STAFF REPORT

HEARING DATE: April 7, 2022
TO: Planning & Zoning Commission
FROM: Sonya Allen, Associate Planner
208-884-5533
SUBJECT: H-2022-0008 – Records Apartments

LOCATION: Northeast corner of N. Records Way and E. Fairview Ave., in the SW 1/4 of Section 4, T.3N., R.1E (Parcel #S1104347005)

A. Site Plan (date: 4/20/2022 4/5/2022) & Rendering – Revised

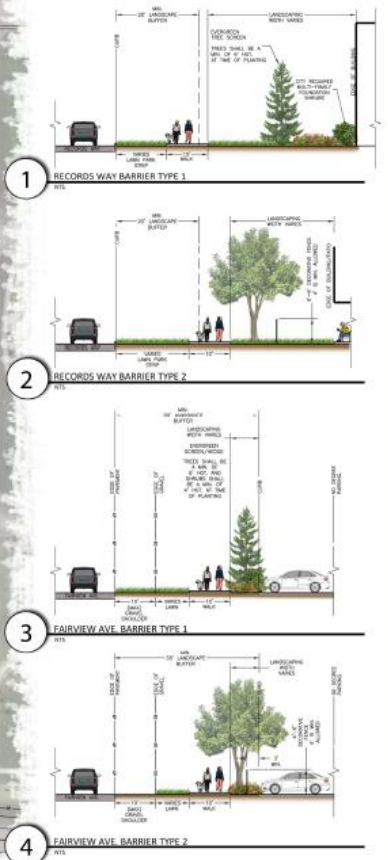
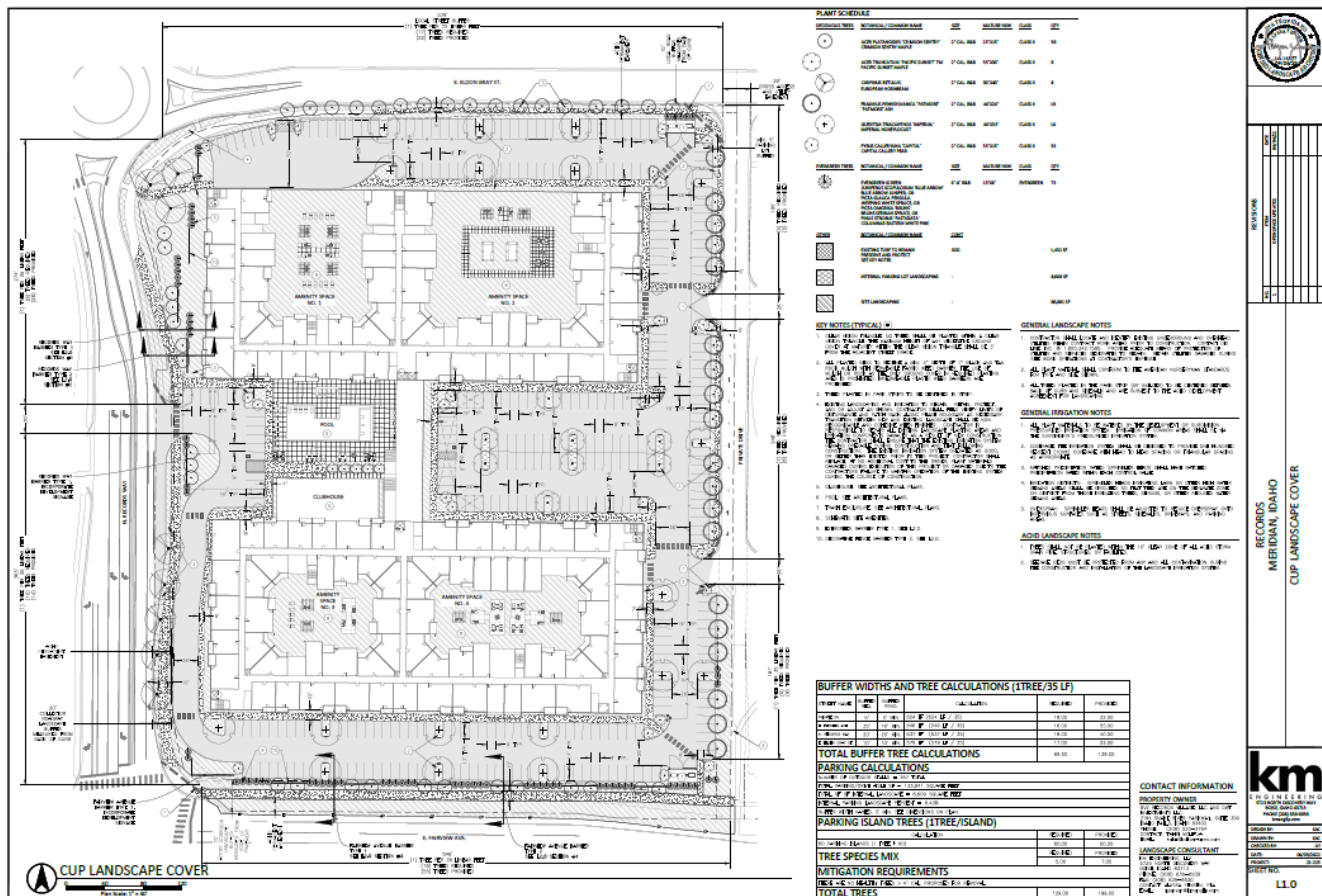
Landscaping is required within parking lots in accord with the standards listed in UDC 11-3B-8C. **The three (3) "diamond" planter islands between the north & south portions of the building do not meet the standards in UDC 11-3B-8C.2, which require planters to contain a minimum of 50 square feet and run the length of the parking space; the site/landscape plan should be revised accordingly. Where bumpers overhang perimeter landscaping in parking areas, the parking stall dimensions may be reduced 2' in length if 2' is added to the width of the landscaped area planted in groundcover; otherwise, wheel stops should be provided to prevent vehicle overhang. The perimeter buffers/parking along the south and east boundaries of the site should be revised to comply with this standard.**

Pathways: The Pathways Master Plan depicts 10-foot wide multi-use pathways along E. Fairview Ave. and N. Records Way providing pedestrian connections to Kleiner City Park; pathways are proposed in accord with the Plan. **A 14-foot wide public pedestrian easement is required to be submitted to the Planning Division prior to or concurrent with the Certificate of Zoning Compliance application as**

- e. Remove the three (3) “diamond” planter islands between the north & south portions of the building and replace them with planter islands that comply with the standards in UDC [11-3B-8C.2](#).

6. Submit a 14-foot wide public pedestrian easement for the 10-foot wide pathways required along the southern and western boundaries of the site in accord with Park's Department [requirements](#) prior to or with the Certificate of Zoning Compliance application. *If partially located within the public right-of-way, provide sufficient easement width beyond that boundary to cover the 10' sidewalk plus 2'.*

B. Landscape Plan (dated: ~~1/20/22~~ 4/5/22) – Revised

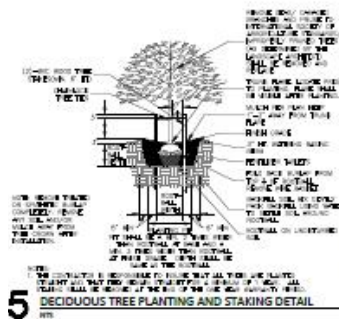
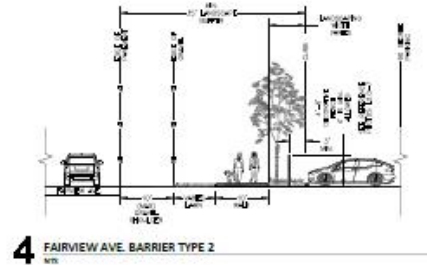
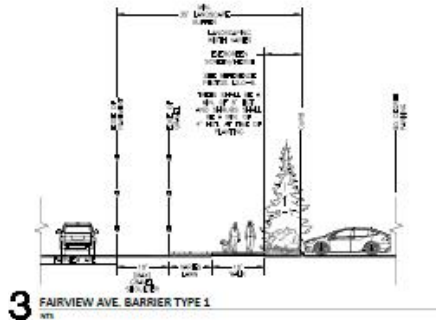
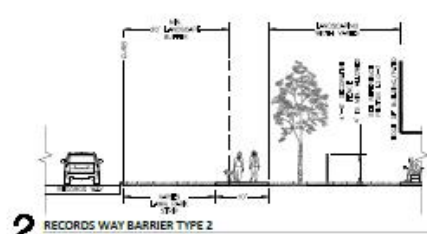
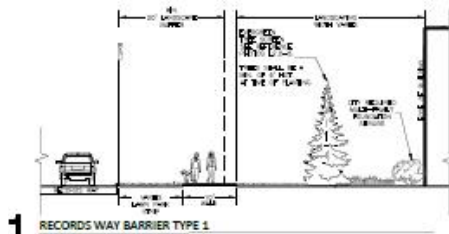
Landscaped street buffers are required to be provided as follows: a 35-foot wide street buffer is required along E. Fairview Ave., an entryway corridor; a 20-foot wide buffer is required along N. Records Way, a collector street; and a 10-foot wide buffer is required along E. Elden Gray St., a local street, per UDC Table 11-2B-3 and landscaped per the standards listed in UDC [11-3B-7C.3](#). **Some portions of the buffers along Records and Fairview are below the required widths and should be revised. All buffers are required to be planted with a variety of trees, shrubs, lawn or other vegetative groundcover and designed to elicit design principles including rhythm, repetition, balance and focal elements per the recently updated specifications; the landscape plan shall be revised accordingly.**

Landscaping is required to be provided along all pathways per the standards listed in UDC [11-3B-12C](#), which require a mix of trees, shrubs, lawn and/or other vegetative groundcover. **Shrubs should be added to the landscape plan in accord with this standard where none are depicted.**

- b. Depict landscaping along the foundations of all street facing elevations as set forth in UDC [11-4-3-27E.2](#).
 - c. Depict a minimum 35-foot wide street buffer along E. Fairview Ave., an entryway corridor; a minimum 20-foot wide buffer along N. Records Way, a collector street; and a minimum 10-foot wide buffer along E. Elden Gray St., a local street, per UDC Table 11-2B-3.

- d. Within street buffers, depict a *variety* of trees, shrubs, lawn or other vegetative groundcover designed to elicit design principles including rhythm, repetition, balance and focal elements per the recently updated specifications set forth in UDC [11-3B-7C.3](#).

- f. Shrubs shall be added to the landscape strips along pathways where none currently exist in order to contribute to the *mix* of landscaping required by UDC [11-3B-12C.2](#).

C. Qualified Open Space (dated: 12/8/21, stamped on ~~1/25/22~~ 4/6/22)

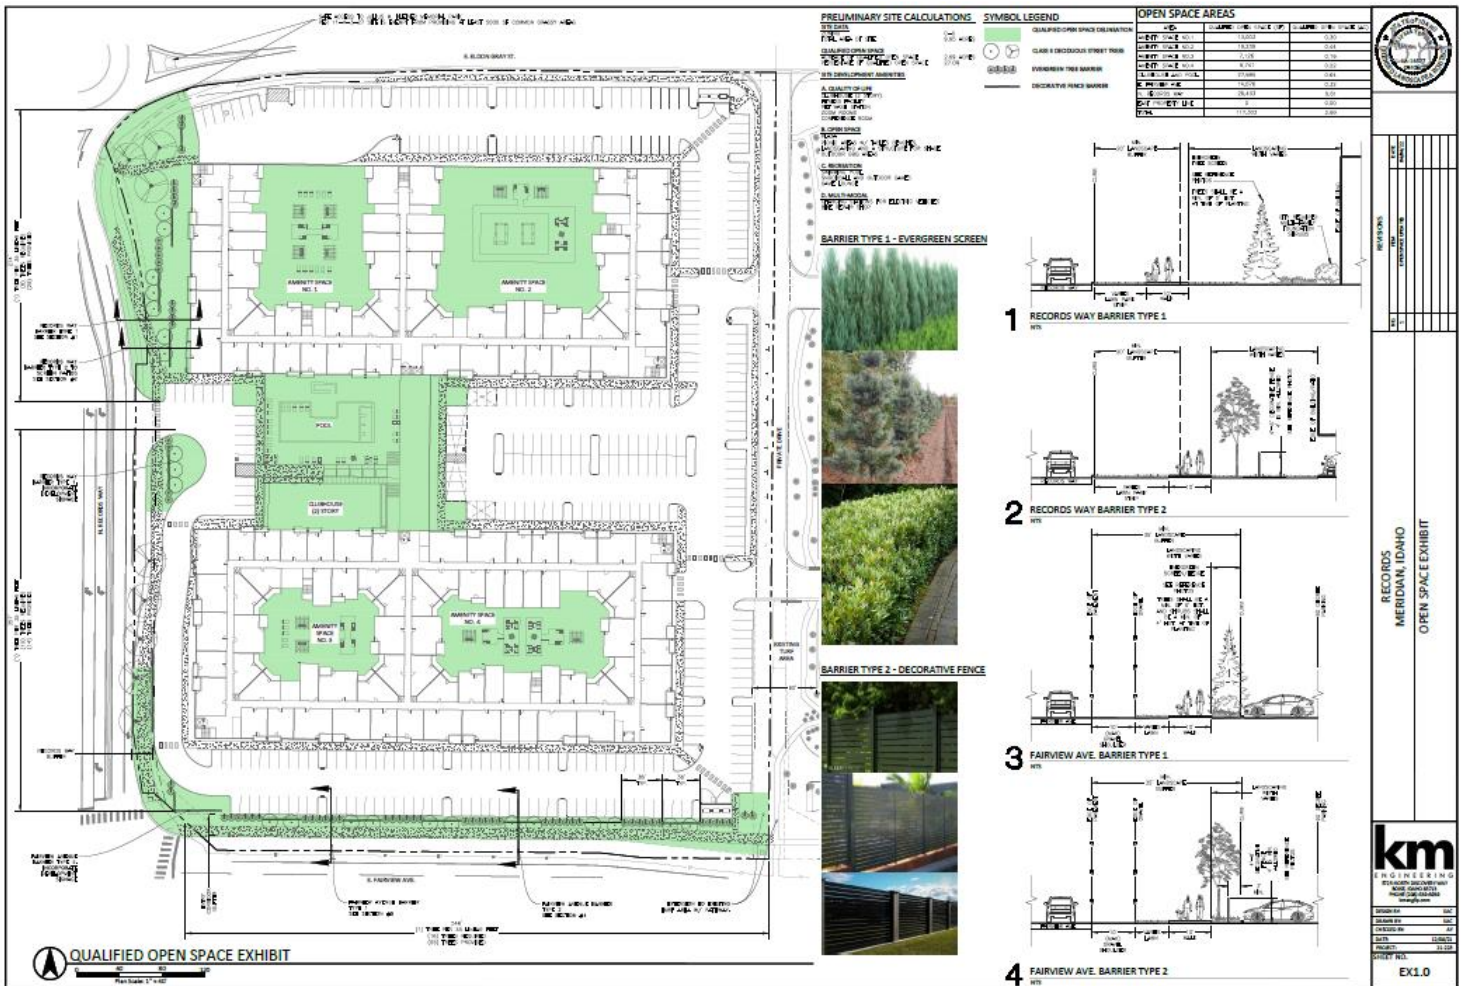
The open space exhibit in Section VIII.C depicts a total of 2.75 acres (or 27.7%) of common open space for the development consisting of four (4) internal amenity spaces, the clubhouse and swimming pool area, street buffers along Records (a collector street) and Fairview (an arterial street), and buffer along the southern portion of the east boundary of the site. Per UDC 11-4-3-27C.5, common open space areas shall not be less than 400 square feet in area, and shall have a minimum length and width dimension of 20 feet. **The buffer along the southern portion of the east boundary of the site and the southern portion of the street buffer along N. Records Way is below 20 feet in width and does not meet this standard.** Per UDC 11-4-3-27C.7, unless otherwise approved through the conditional use process, common open space areas shall not be adjacent to collector or arterial streets unless separated from the street by a berm or constructed barrier at least four feet (4') in height, with breaks in the berm or barrier to allow for pedestrian access. **The buffers along Records and Fairview are not separated from the street by a berm and do not meet this standard. Staff recommends a revised open space exhibit is submitted that provides a minimum of 3.74 acres of qualified open space meeting the minimum standards noted above and in UDC 11-4-3-27C prior to the Commission acting on this application. The reduction in the number of units as recommended may result in extra area for common open space to be provided meeting the minimum standards.**

- m. Depict common open space that complies with the dimensional standards in UDC 11-4-3-27 (i.e. shall not be less than 400 square feet in area and shall have a minimum length and width dimension of 20 feet). Given the project's proximity to Kleiner Park, the Applicant shall submit an Alternative Compliance application for the baseline open space requirement.
